Subject: Response to the FCC Correspondence Reference # 31233 for additional information on RIM BlackBerry Handheld FCC ID: L6ARAV20CW, 731 Confirmation # EA459850.

The following addresses the comment on your **Correspondence Reference # 31233**, dated July 26, 2006.

Input level measurement analyzer plots for the sinusoidal 1.025 kHz signal

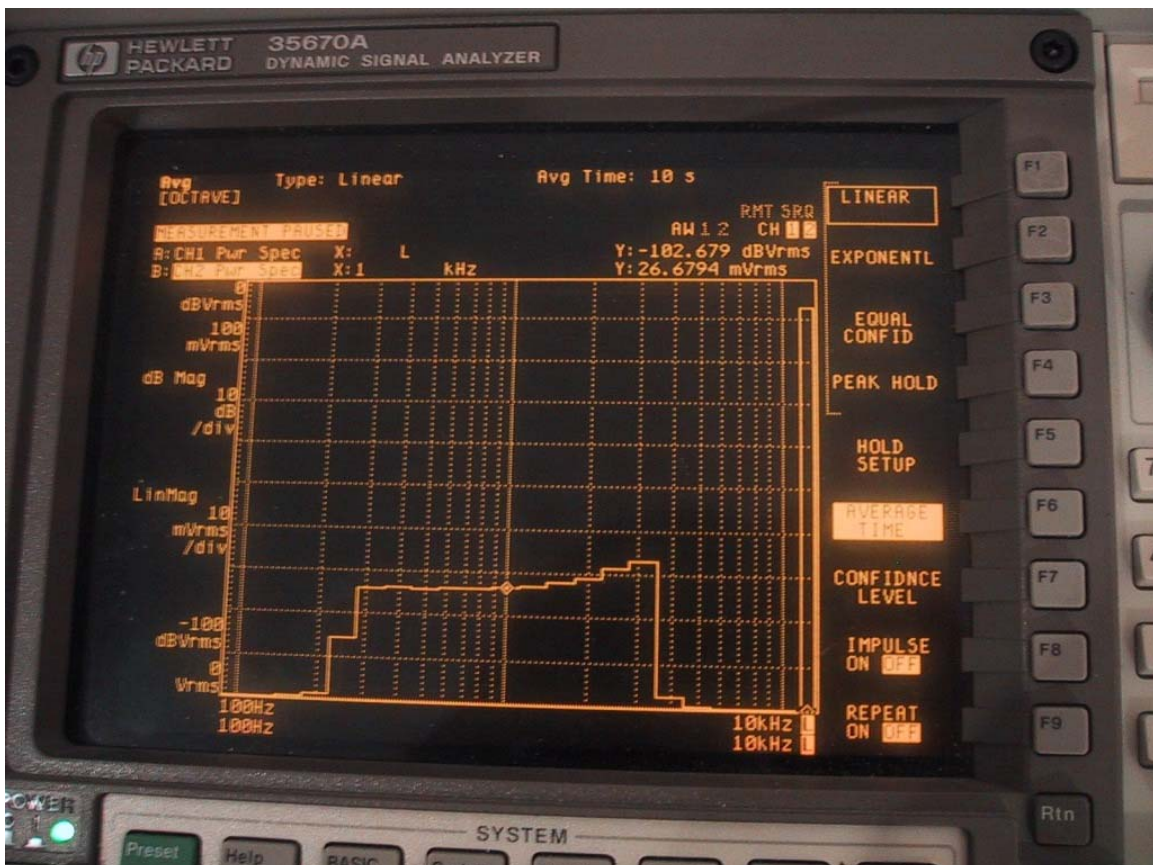
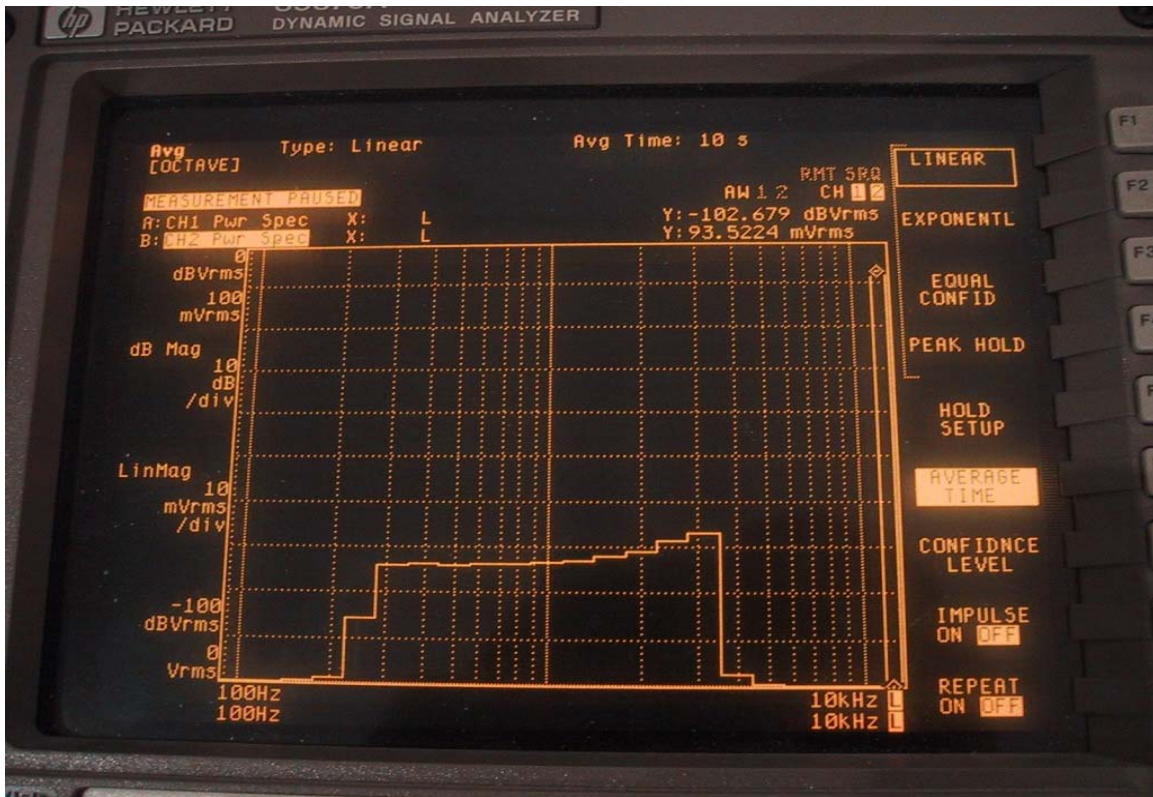
A) Regarding your answer to question 1 Please update the report to list file lengths, averaging times and any other measurement specific related information such as BWC for all measurements. Please include measurement of the input reference level. Please also specify averaging times for ABM2. Related textual explanations should be comprehensive and clear. FYI Please note that integration times for the measurement should typically be equal to that used for the reference level measurement.

Time averaging was used with an artificial speech based signal when setting the input reference level. The averaging period was adequate to cover the signal period and the averaging method was the same for setting the reference level and performing the measurement.

A Dynamic Signal Analyzer was used to measure the time averaging of the speech-simulated signal. The analyzer was set to measure the audio signal at 1/3 octave with 10 seconds time averaging. The speech simulated signal duration is 2 seconds and the sinusoidal signal duration is 10 seconds. The DASY4 program was set to repeat the audio file while performing time averaging.

Signal type	1.025 kHz sinewave	48k_voice_300-3000
Signal length (s)	10	2
Time per location for ABM1, ABM2 and input level (s)	10	10
Averaging over signal repetitions	1	5

Please see new plots for the input signal measured with external analyzer DASY4 software:

The following are ABM2 measurement data and plots for supported speech service options, vocoder type and RF channel to show justification:

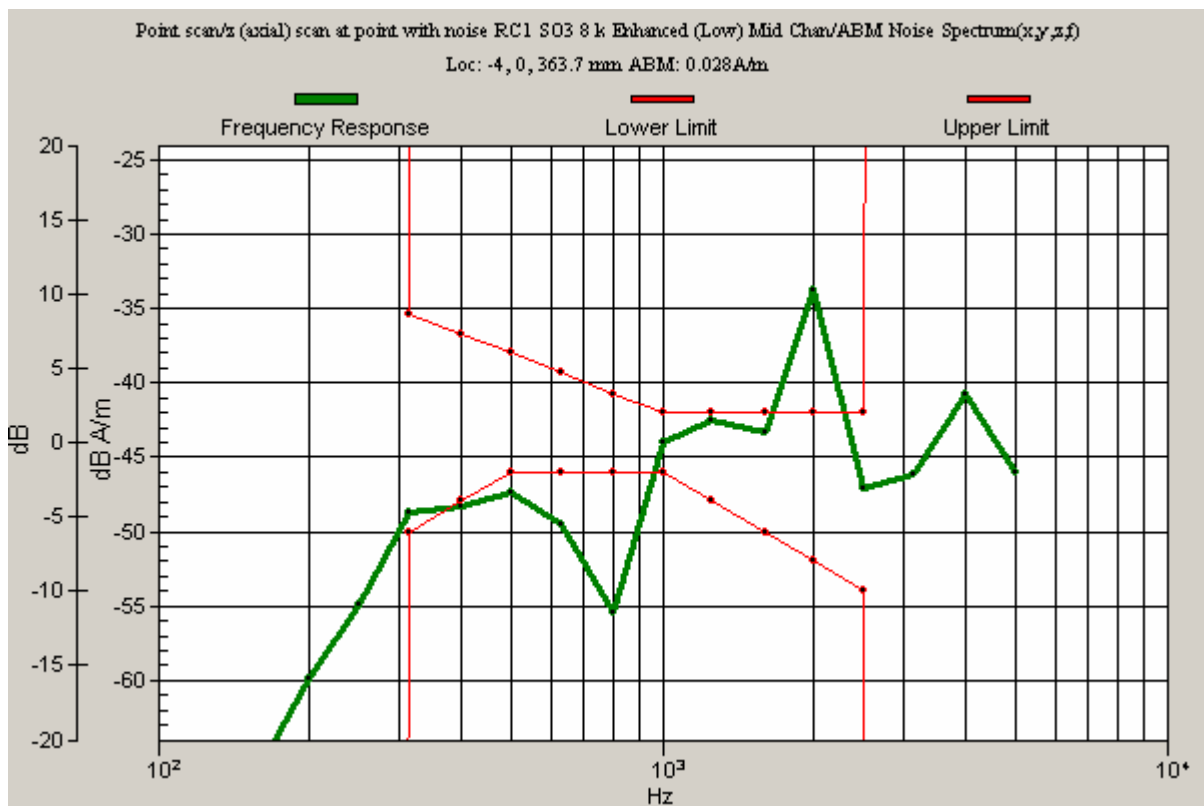
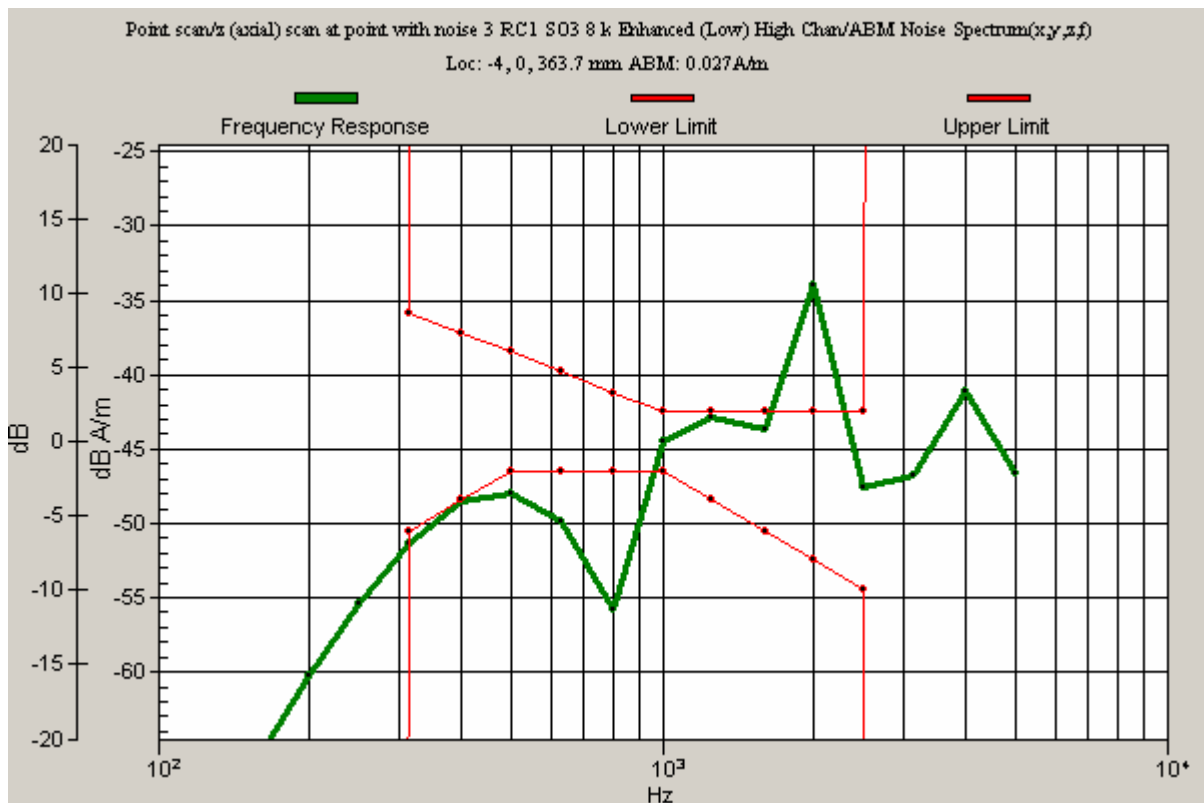
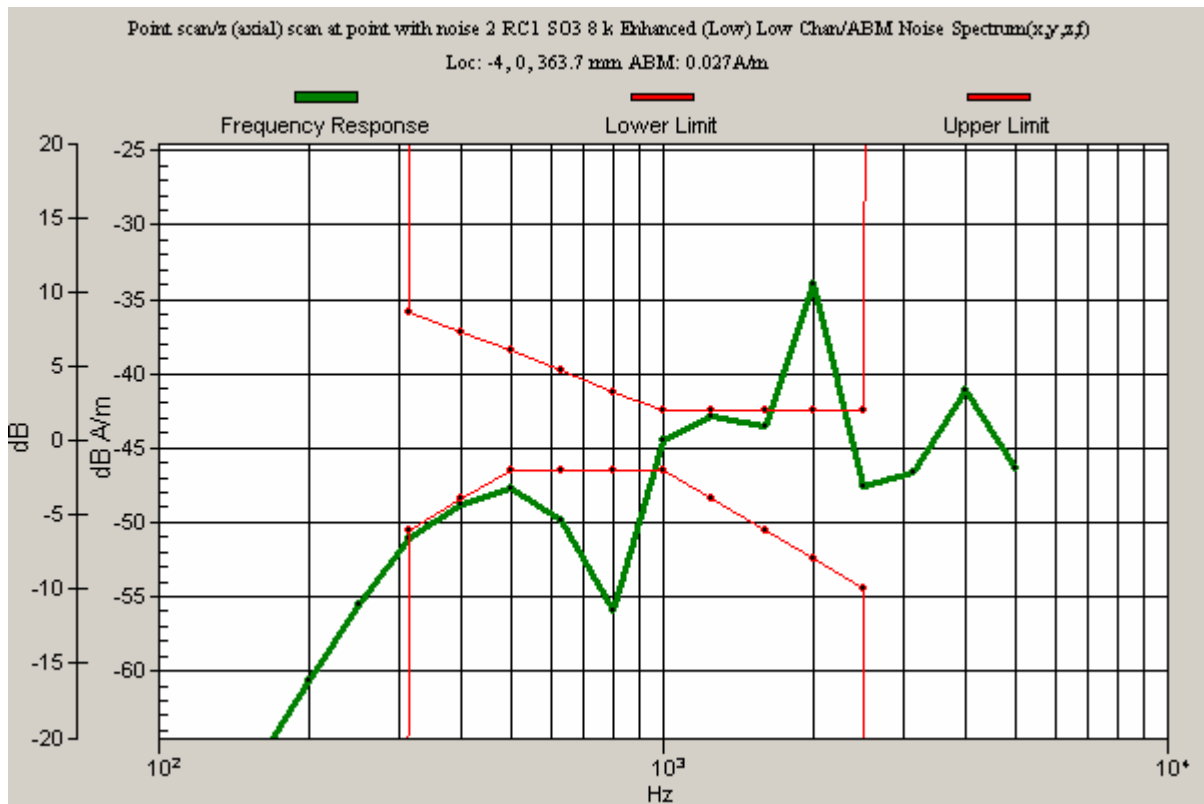
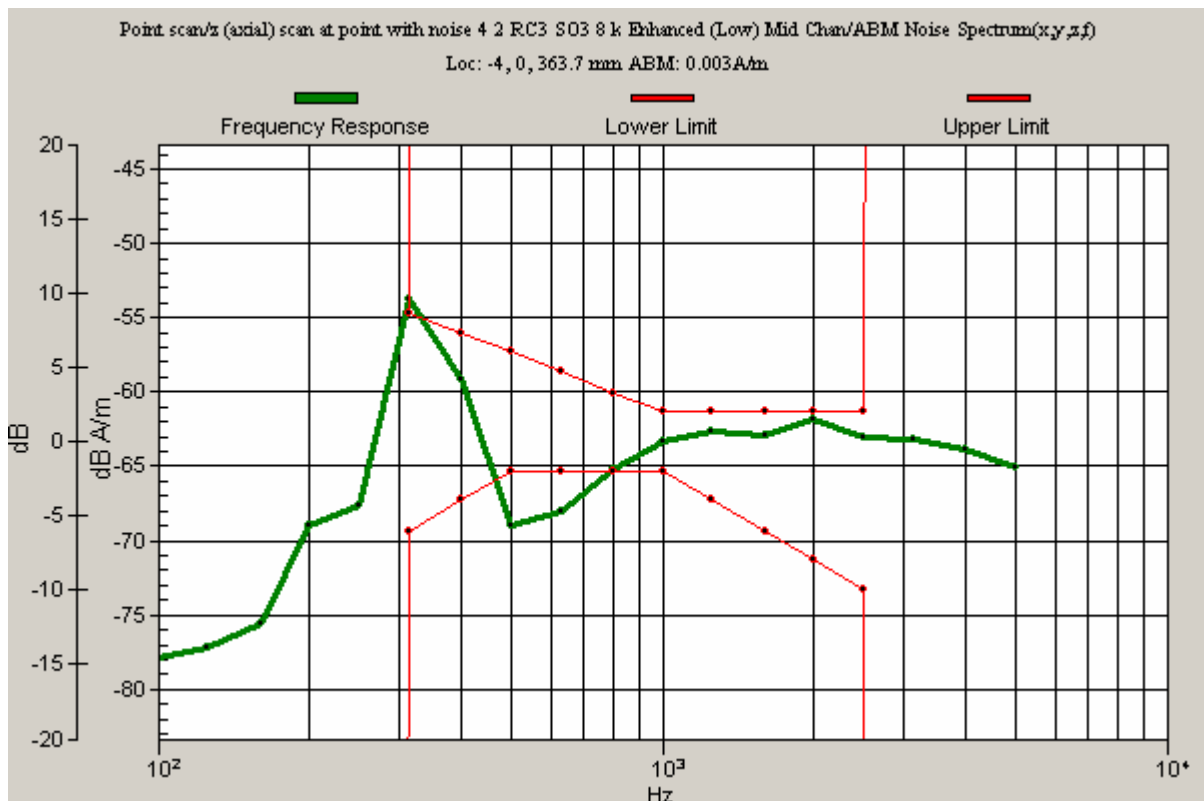
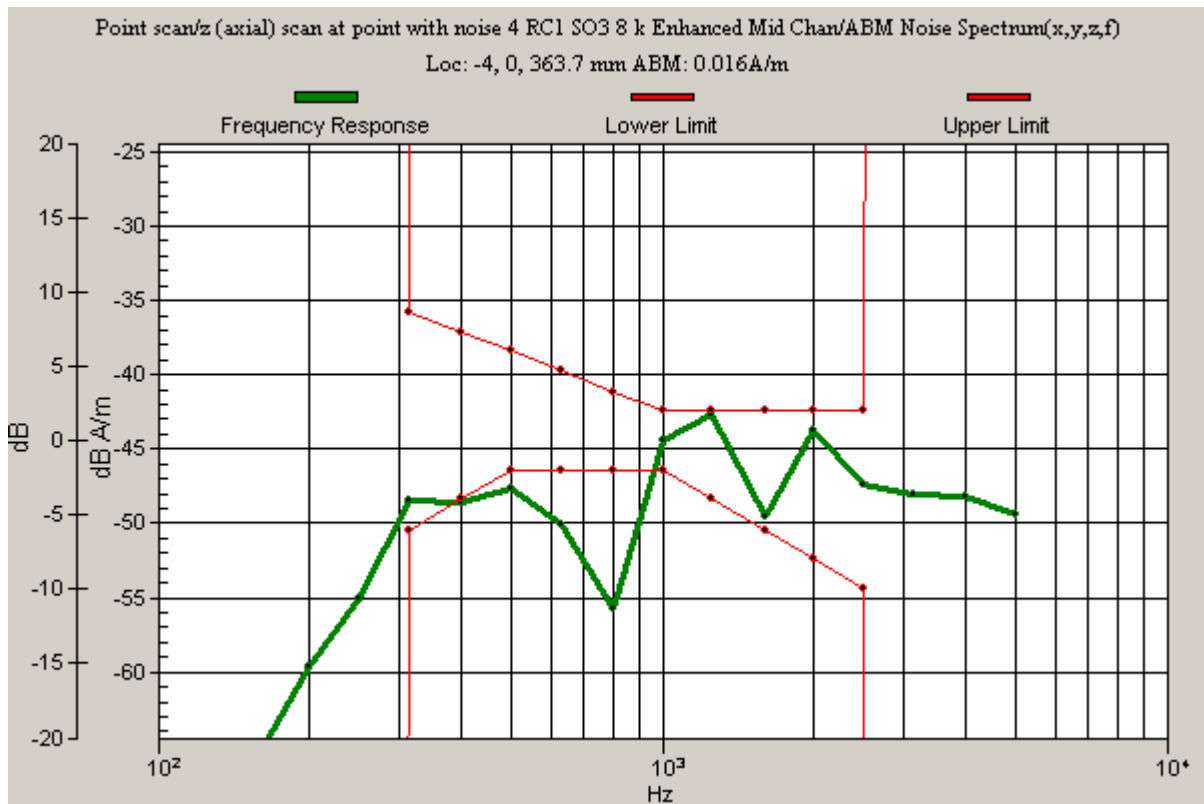
C) Regarding your answer to question 3. Please readdress. The procedure mentioned pertains to SAR testing not HAC. Please justify the subset tested in accordance with the FCC 3G procedure for HAC. Also, you mentioned that the device has both 8K enhanced and 8K enhanced low. Please address both or justify subset testing.

Service Option: 3
Radio Configuration 1 and 3
Vocoder type: 8k Enhanced (Low) / 8k Enhanced

These were evaluated and the worst case ABM2 was determined to be RC1, SO3 and 8k Enhanced (Low), mid channel.
In addition, the RF environment (M rating) for T-Coil rating was determined by evaluating 1/8 th rate RC1, SO2 option. This option does not have a vocoder to perform ABM measurements.

Point scan/z (axial) scan at point with noise RC1 SO3 8 k Enhanced (Low) Mid Chan/ABM Noise(x,y,z) (1x1x1):

ABM2 = -31.1467 dB A/m

Point scan/z (axial) scan at point with noise 2 RC1 SO3 8 k Enhanced (Low) Low chan/ABM Noise(x,y,z) (1x1x1):

ABM2 = -31.2454 dB A/m

Point scan/z (axial) scan at point with noise 3 RC1 SO3 8 k Enhanced (Low) High Chan/ABM Noise(x,y,z) (1x1x1):

ABM2 = -31.2139 dB A/m

Point scan/z (axial) scan at point with noise 4 RC1 SO3 8 k Enhanced Mid Chan/ABM

ABM2 = -35.676 dB A/m

Point scan/z (axial) scan at point with noise 4 2 RC3 SO3 8 k Enhanced (Low) Mid

ABM2 = -49.6989 dB A/m
